Model: Martini-C2	Date: 14-Oct-04	No.: RB140001b
-------------------	-----------------	----------------

Subject: Firmware Release History (BCU - Engine)		Prepared by: S. Watanabe	
From: 2nd Tech Support Sec. Service Support Dept.			
Classification:	<input type="checkbox"/> Troubleshooting	<input type="checkbox"/> Part information	<input type="checkbox"/> Action required
	<input type="checkbox"/> Mechanical	<input type="checkbox"/> Electrical	<input type="checkbox"/> Service manual revision
	<input type="checkbox"/> Paper path	<input type="checkbox"/> Transmit/receive	<input type="checkbox"/> Retrofit information
	<input checked="" type="checkbox"/> Other ()

This RTB has been issued to announce the firmware release information for the Engine.

1. Page 1-13 (Installation)

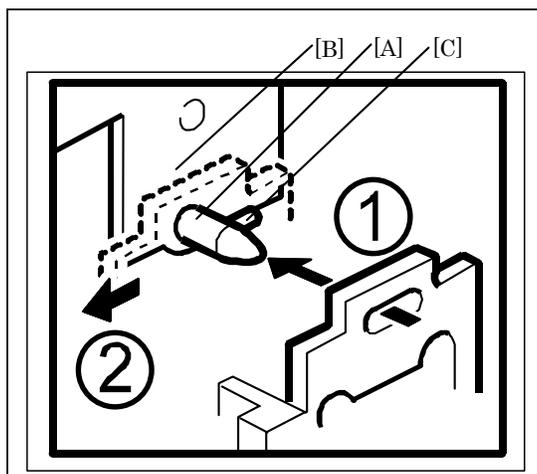
The following sections of the Service Manual were changed.

Re-installing the Development Unit

14. Push the development unit all the way to the right.
15. Continue to hold the unit to the right and push it into the machine.
Important: Make sure the pin [A] goes into the left side of the hole in the development unit plate.
16. Push the development unit all the way in, so that the development unit plate touches the mainframe plate [B].
Important: Make sure you can see the small pin [C] in front of the plate. If you cannot move the development unit plate behind the small pin, turn the front gear of the unit to the left, and try again.
17. Push the development unit to the left, until it contacts the PCU.
18. Make sure the pipeline shutter is rotated down to the open position.

2. Page 3-33 (Replacement and Adjustment)

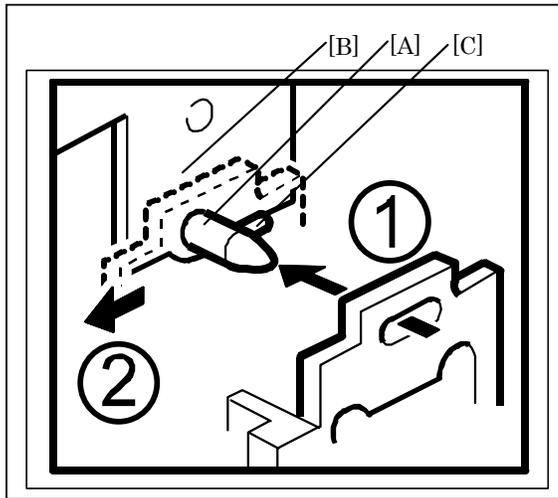
3.6.1 Development Unit Removal

Re-installation

1. Push the development unit all the way to the right.
2. Continue to hold the unit to the right and push it into the machine.
Important: Make sure the pin [A] goes into the left side of the hole in the development unit plate.
3. Push the development unit all the way in, so that the development unit plate touches the mainframe plate [B].
Important: Make sure you can see the small pin [C] in front of the plate. If you cannot move the development unit plate behind the small pin, turn the front gear of the unit to the left, and try again.
4. Push the development unit to the left, until it contacts the PCU.
5. Make sure the pipeline shutter is rotated down to the open position.

1. Pg. 1-11 (Installation)

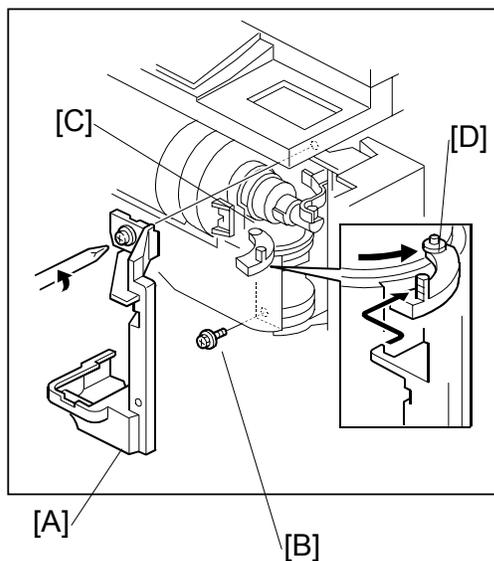
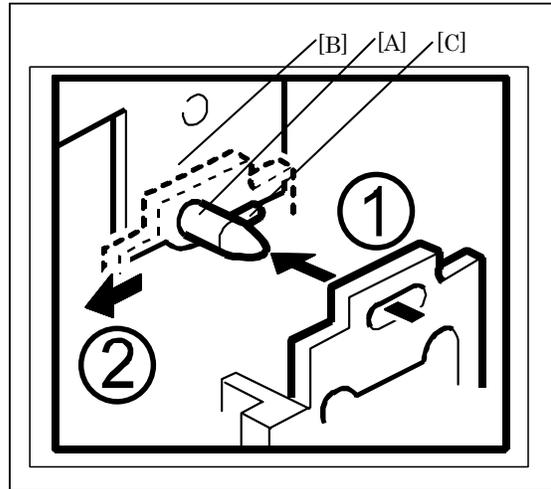
The following procedures in the Service Manual were changed (pg. 1-11).

- **Note:** Steps 5-13 of the procedure on pg. 1-11 were not changed.
- **IMPORTANT:** As mentioned below, before you begin the procedure on pg. 1-11, make sure to **remove the toner bottle first**. If the toner bottle is in the machine when you do this procedure, **the toner bottle holder can be damaged**.

IMPORTANT: Before you begin, **remove the toner bottle** if it is installed.

1. Remove the shutter cover [A] of the toner supply unit (⌀ x 1).
2. Remove the lock screw [B] from the toner bottle open/close bracket.
3. Remove the shipping tape [C] if it is still there.
4. Pull the toner bottle holder and swing it to the right.

14. Push the development unit all the way to the right.
15. Continue to hold the unit to the right and push it into the machine.
Important: Make sure the pin [A] goes into the left side of the hole in the development unit plate.
16. Push the development unit all the way in, so that the development unit plate touches the mainframe plate [B].
Important: Make sure you can see the small pin [C] in front of the plate. If you cannot move the development unit plate behind the small pin, turn the front gear of the unit to the left, and try again.
17. Push the development unit to the left until it touches the PCU.
18. Rotate the pipeline shutter down to the open position.
19. Reattach all the parts you removed in Steps 1-4 of this procedure.
Important: Make sure the tab [D] is behind the stay and the lower pin is inside the track.

Important Note for When Replacing the Thermostat

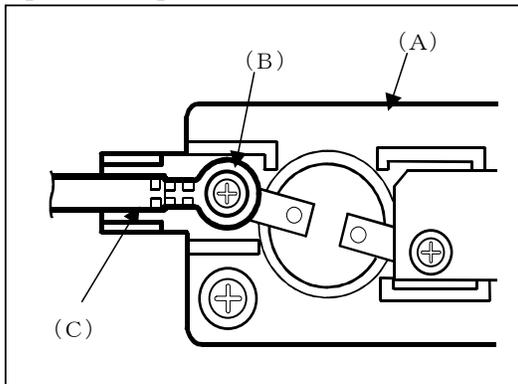
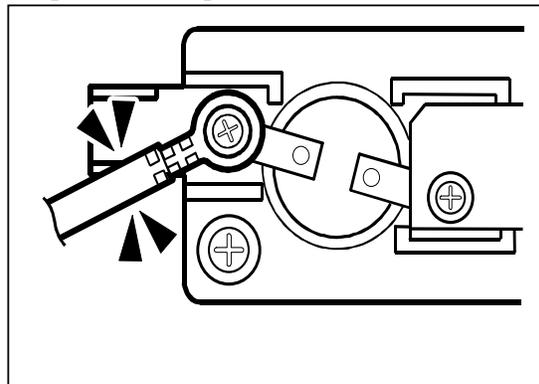
Do the following when you replace the thermostat (P/N#AW110040: Thermostat-192C) on the MT-C2.

[Correct]

[Incorrect]

BCU Board (Base Engine Control Unit)

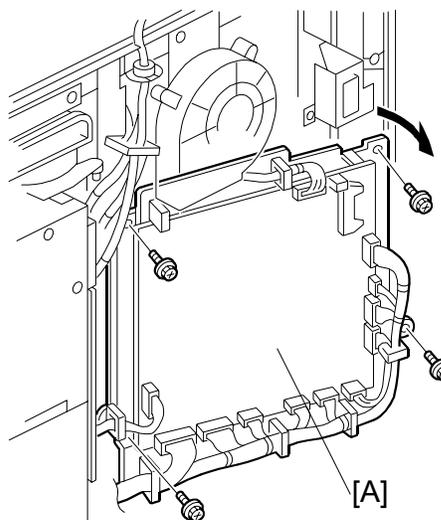
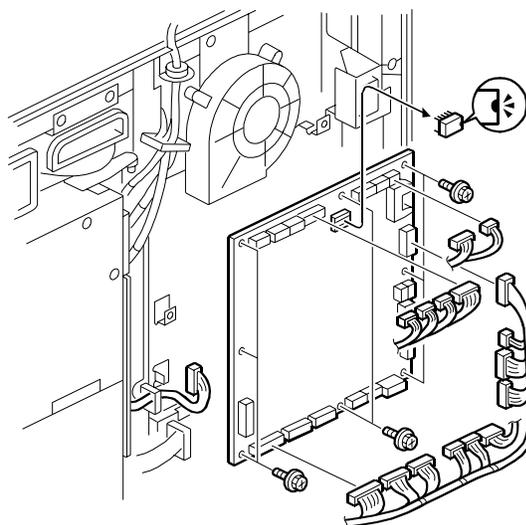
The step in *bold italics* below was added.

1. Rear upper cover (☛ 3.3.5)
2. [A]: BCU board bracket (4 screws)

3. [B]: BCU board (4 screws, 17 connectors)

4. ***Remove IC31 (EEPROM) from the old BCU board, and then attach it to the new BCU board.***

Seal Check And Removal

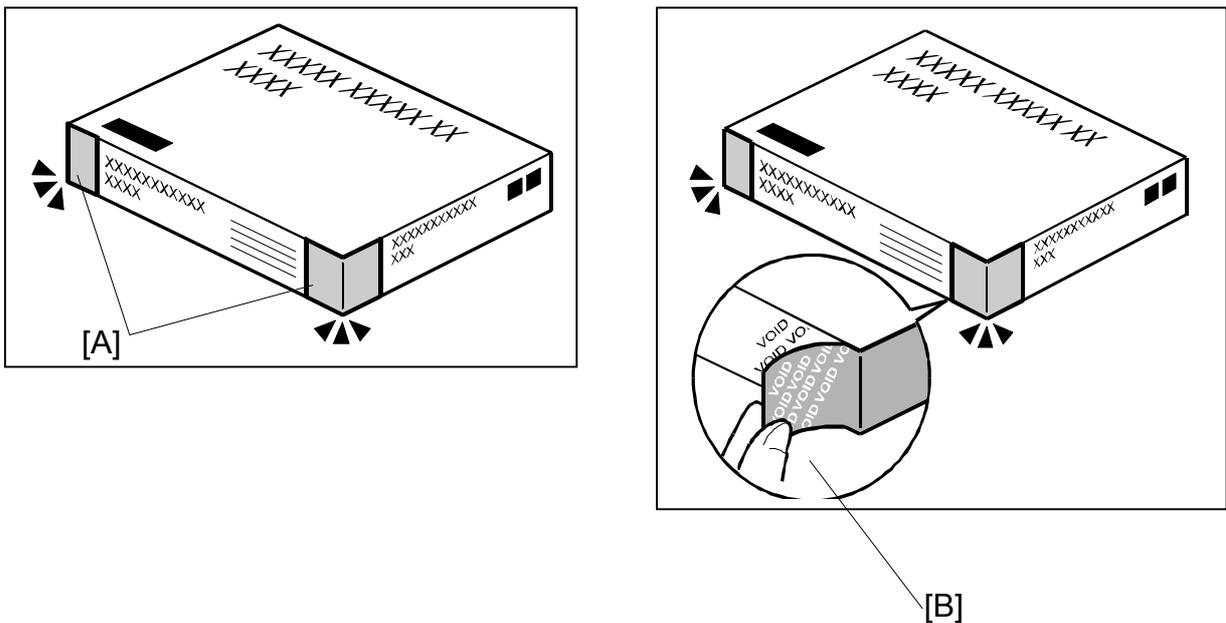
Replace the installation procedure for the Data Overwrite Security Unit Type C or D with the procedure in this RTB (from pg. 2).

- The newly added areas are highlighted in blue.
- The procedure was revised to further increase the level of data security.

1. Make sure that:
 - 1) The box has **two pieces of tape** [A] attached to the corners in the photo, **AND**
 - 2) These two tapes are **blank**.
- If you can see “VOID” on the surface of the tape, DO NOT install the components in the box. Stop this procedure and contact your Sales division.
2. If the results of Step 1 are OK, remove the two pieces of tape from the box.
Note: After you remove the tapes, you will see “VOID” written on the box under the tape [B]. This is normal.

SYMPTOM

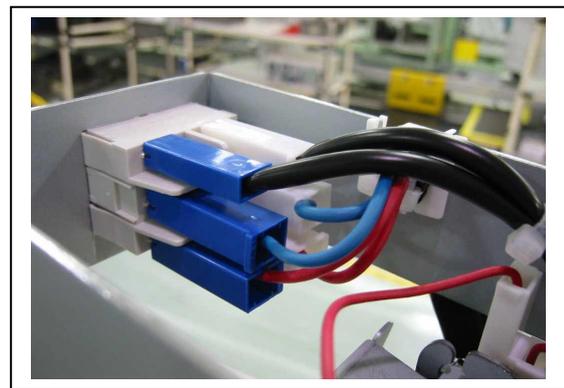
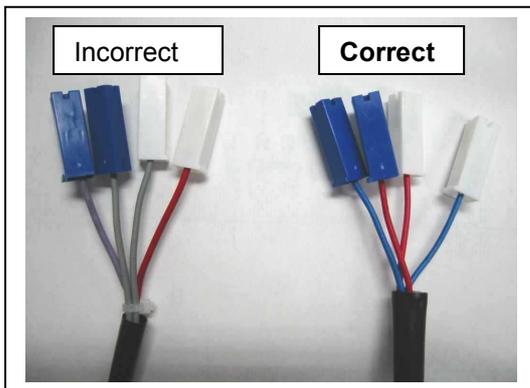
Some cables on the PSU harness are the wrong color.

For the correct colors, see photo below.

When you replace the PSU on the machines listed below, attach the connectors according to the color of the **connectors**. Ignore the color of the harness cables.

Note: Only the color of the cable covering is incorrect. The internal wiring is correct.
